BHARAT HEAVY ELECTRICALS LIMITED
PROJECT ENGINEERING MANAGEMENT, NOIDA

CORRIGENDUM- 07

PROJECT	:	BRBCL, NABINAGAR STPS 4x250 MW FGD
PACKAGE	:	GYP SUM DEWATERING SYSTEM
TENDER ENQUIRY NO	:	PE/PG/RGM/E-6512/2020 Dt. 01/09/2020
DUE DATE EXTENSION		10.11.2020
SUBJECT	:	REGARDING REPLY OF PRE BID QUERY

PROJECT: 4x250 MW NABINAGAR TPP						
		PACKAGE: GYPSUM DEWATERING SYSTEM						
		ENQUIRY NO.: E-6512/2020 Dtd. 01.09.2020						
PRE-BID CLARIFICATION								
1	2	3	4	5	6	7	8	9

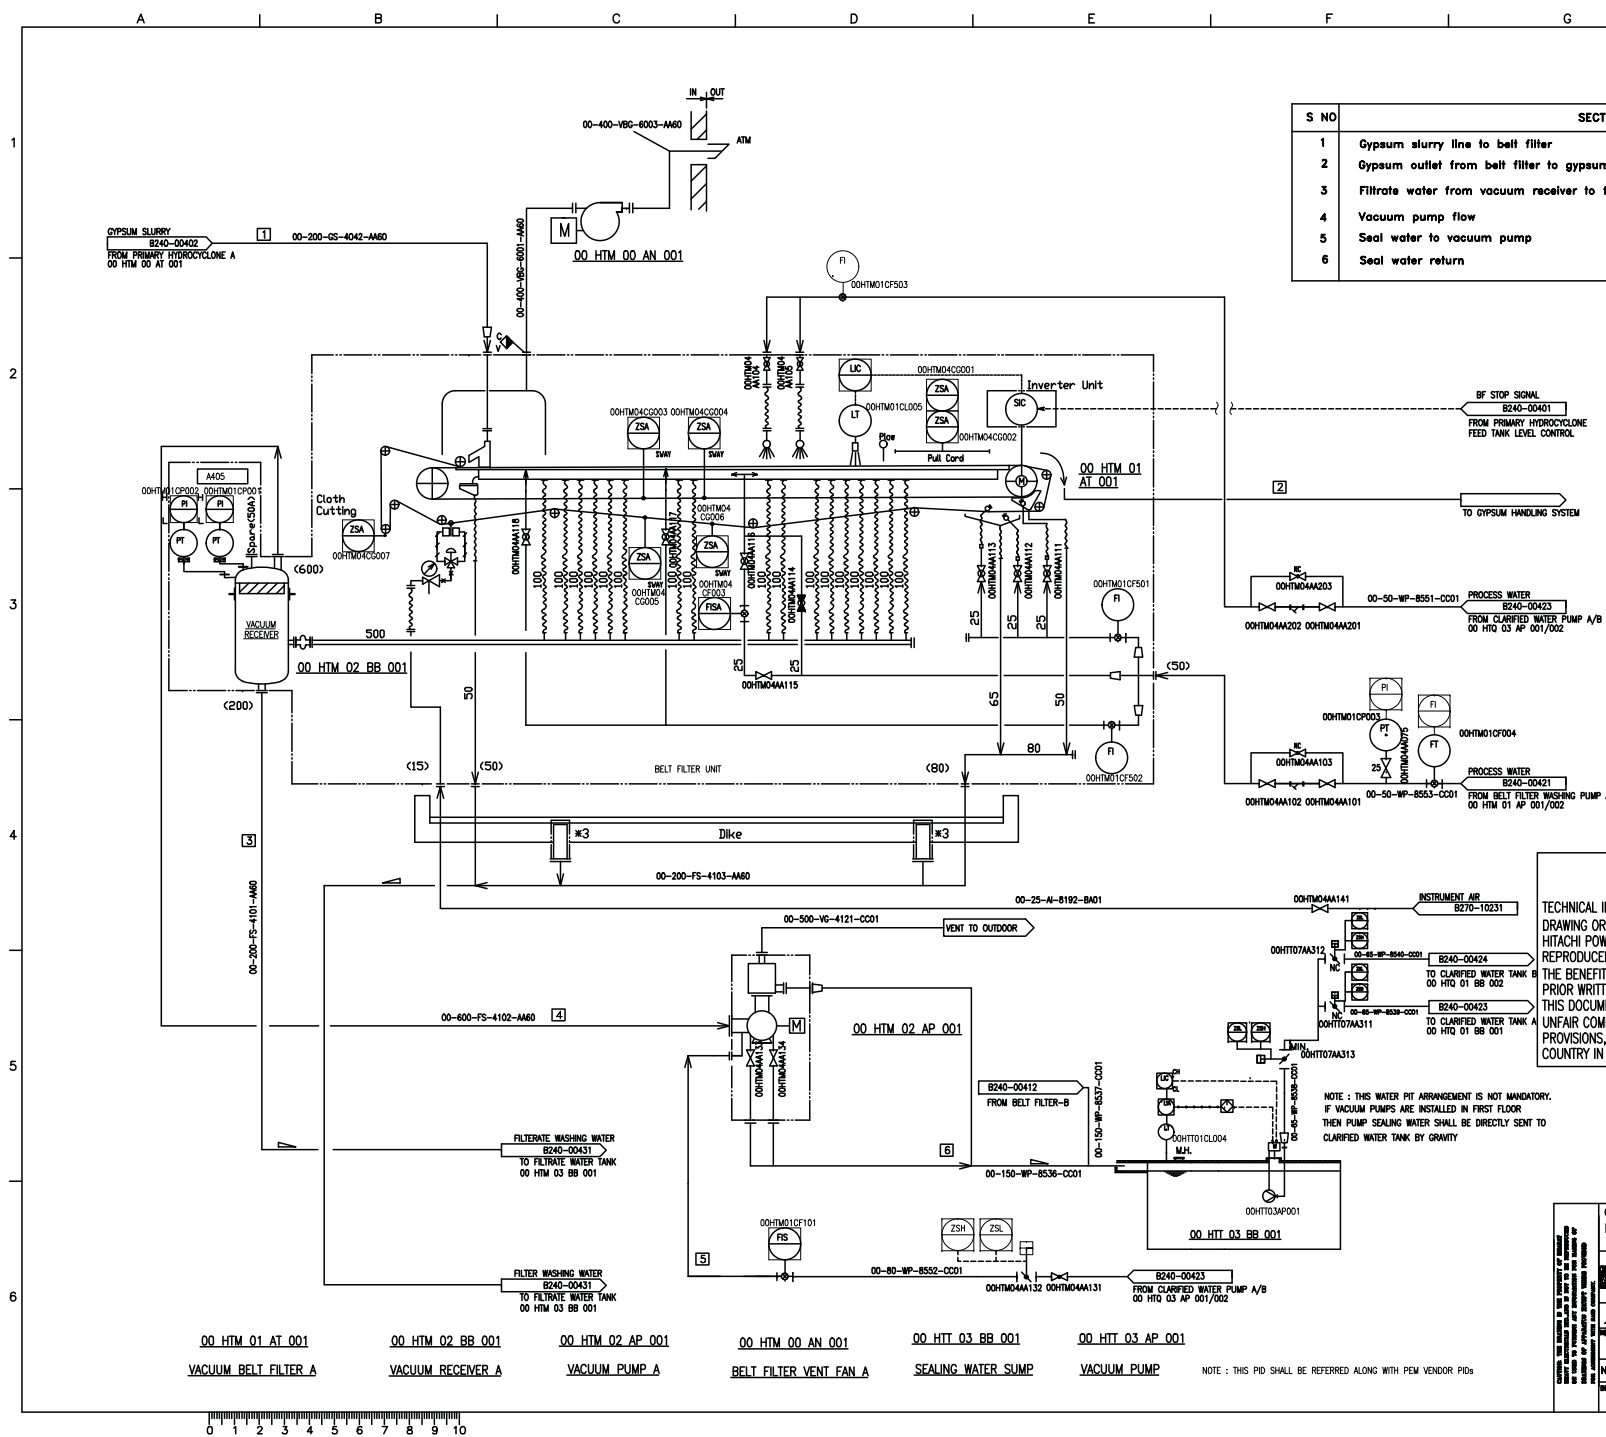
Complete System in Bidder scope EXCEPT:

1. Piping with accessories from Filtrate Extraction Pump to Filtrate Water Tank. Refer Scheme No. PE-FEP-00.
2. Associated drain of vacuum belt filters (drip tray) to filtrate tanks. Refer sub section C1, clause 2.1.1.9 (ii) f of the Specification

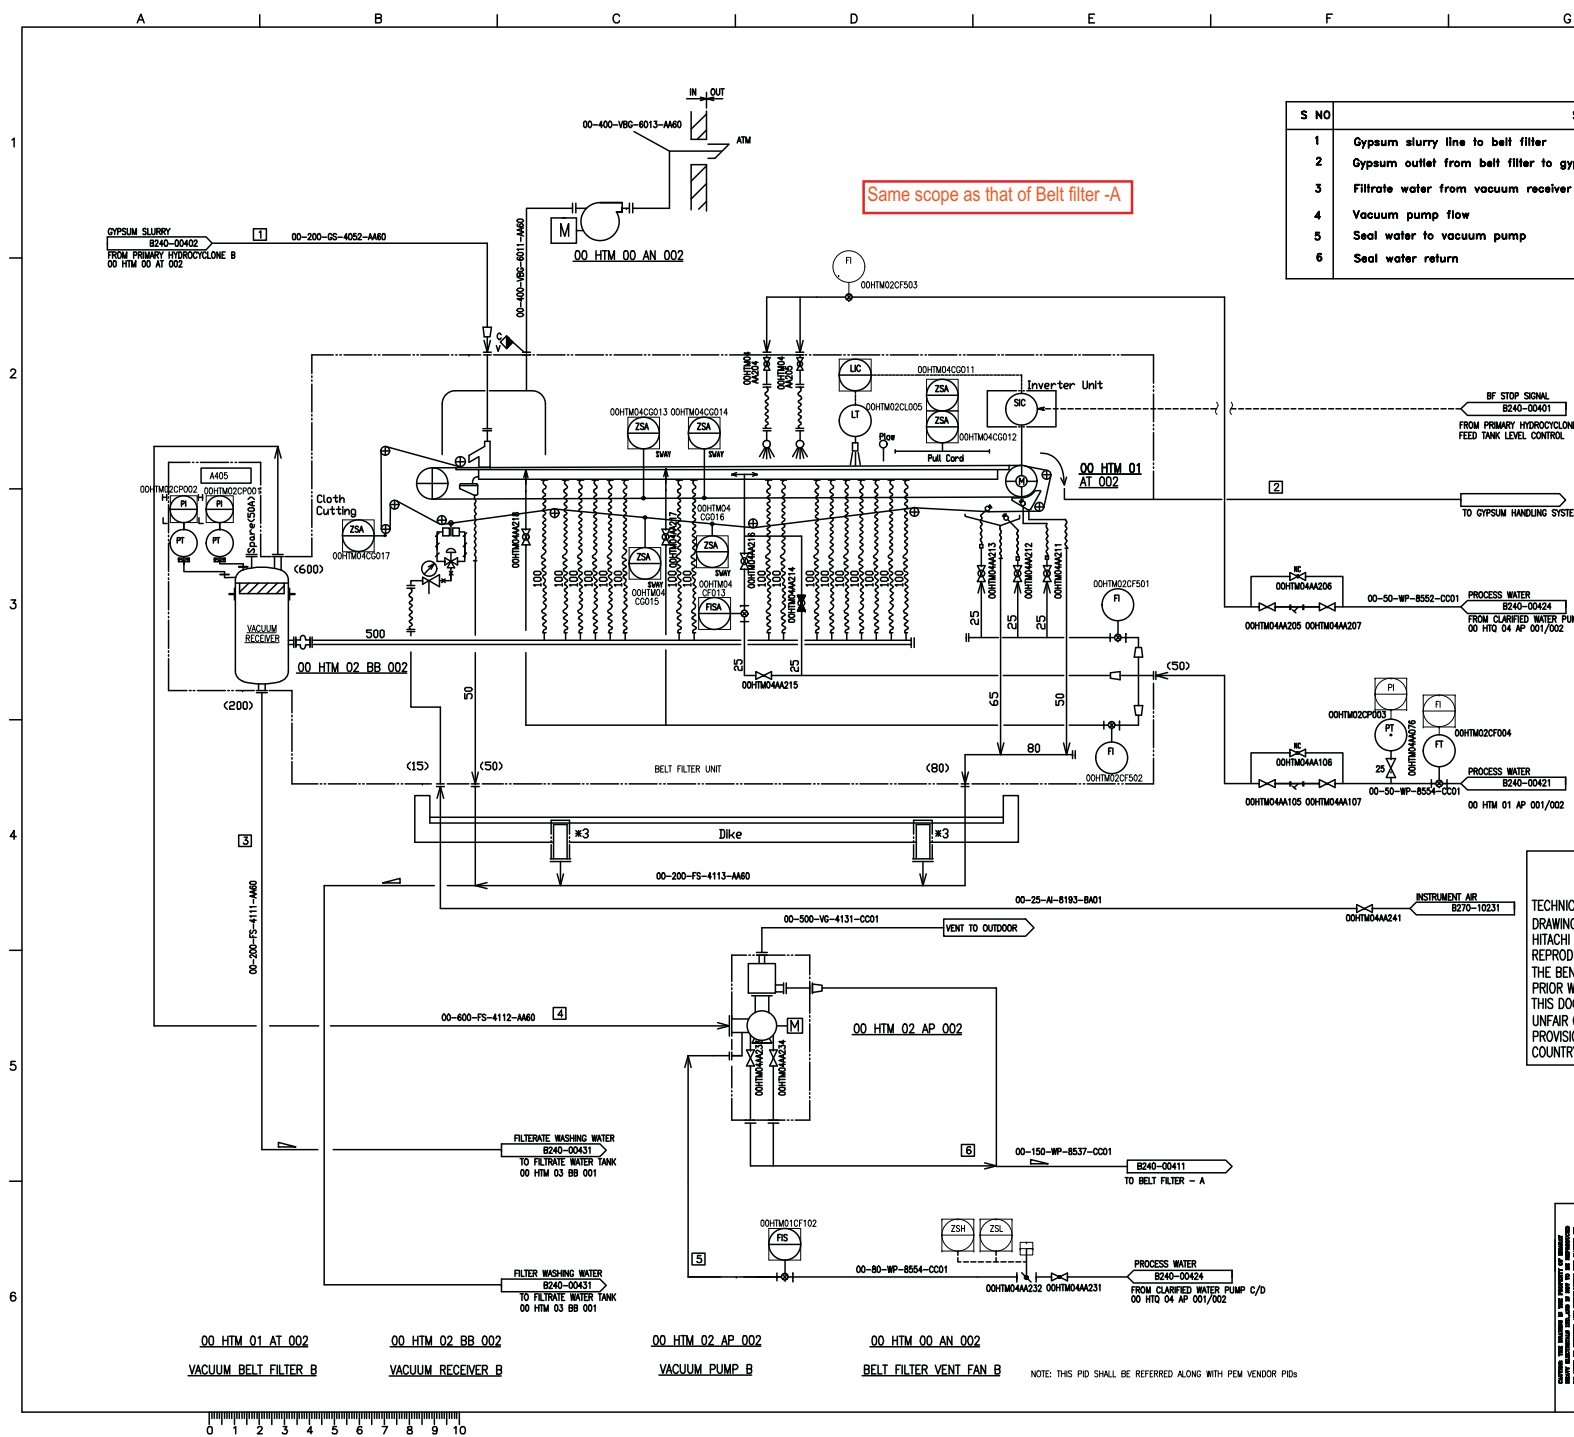
Same scope as that of Belt filter -A

Scheme No.: PE-FEP-00

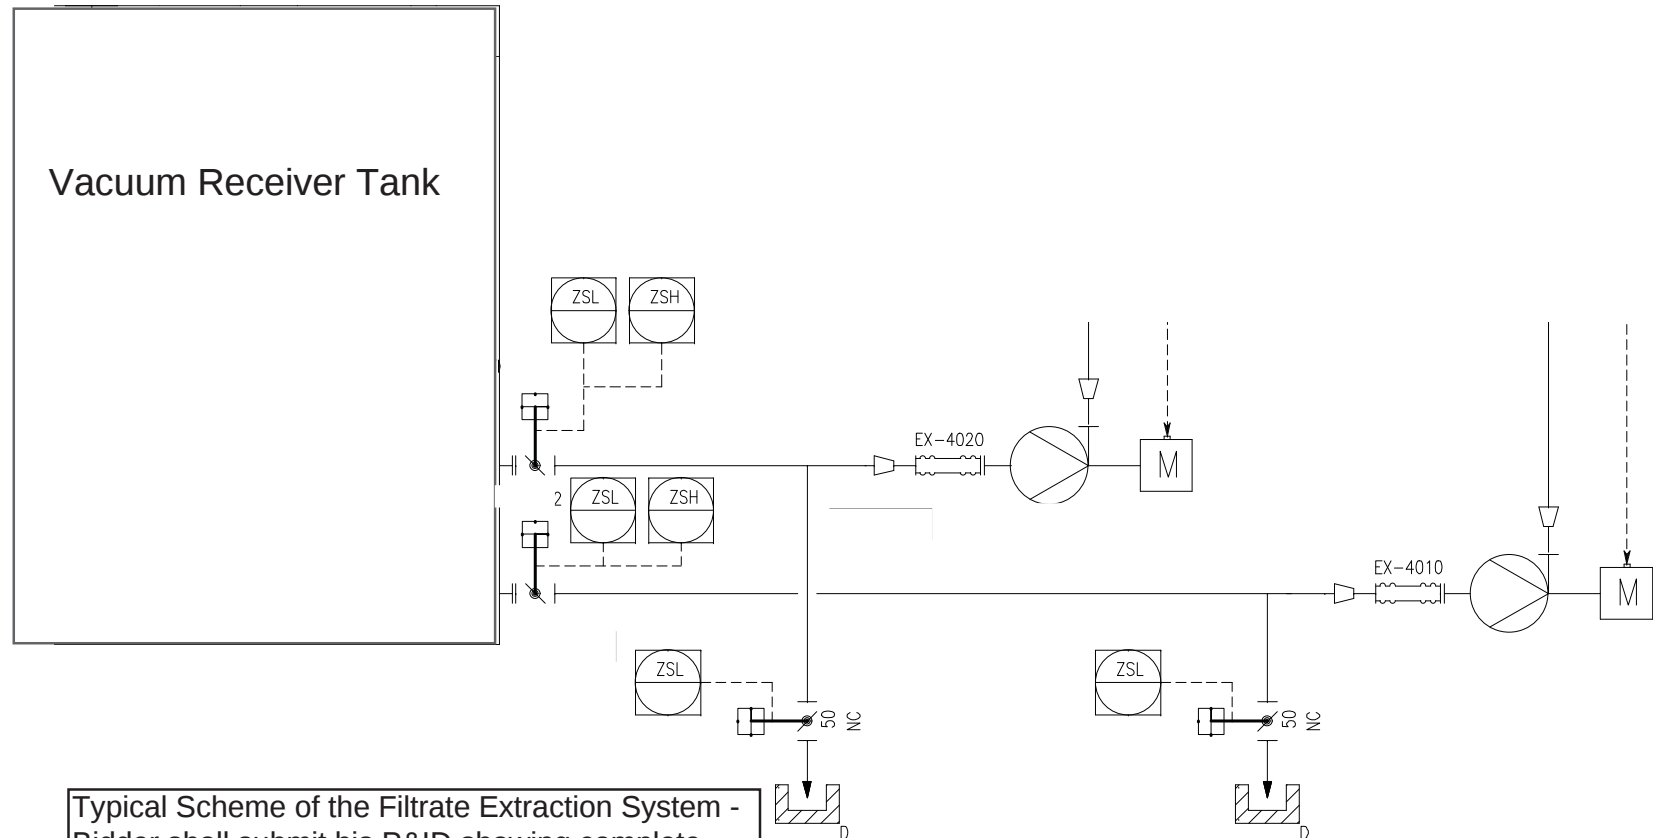
Bidder scope after the Pump Discharge is limited to the Engineering of the Piping up to the Filtrate Water Tank as per Clause 2.1.1.9 (ii) f of Sub-section C1, Section-I of this specification.

Typical Scheme of the Filtrate Extraction System - Bidder shall submit his P&ID showing complete arrangement for BHEL/Customer approval. Piping and Valves shall be rubber lined as per the details provided elsewhere in the specification.
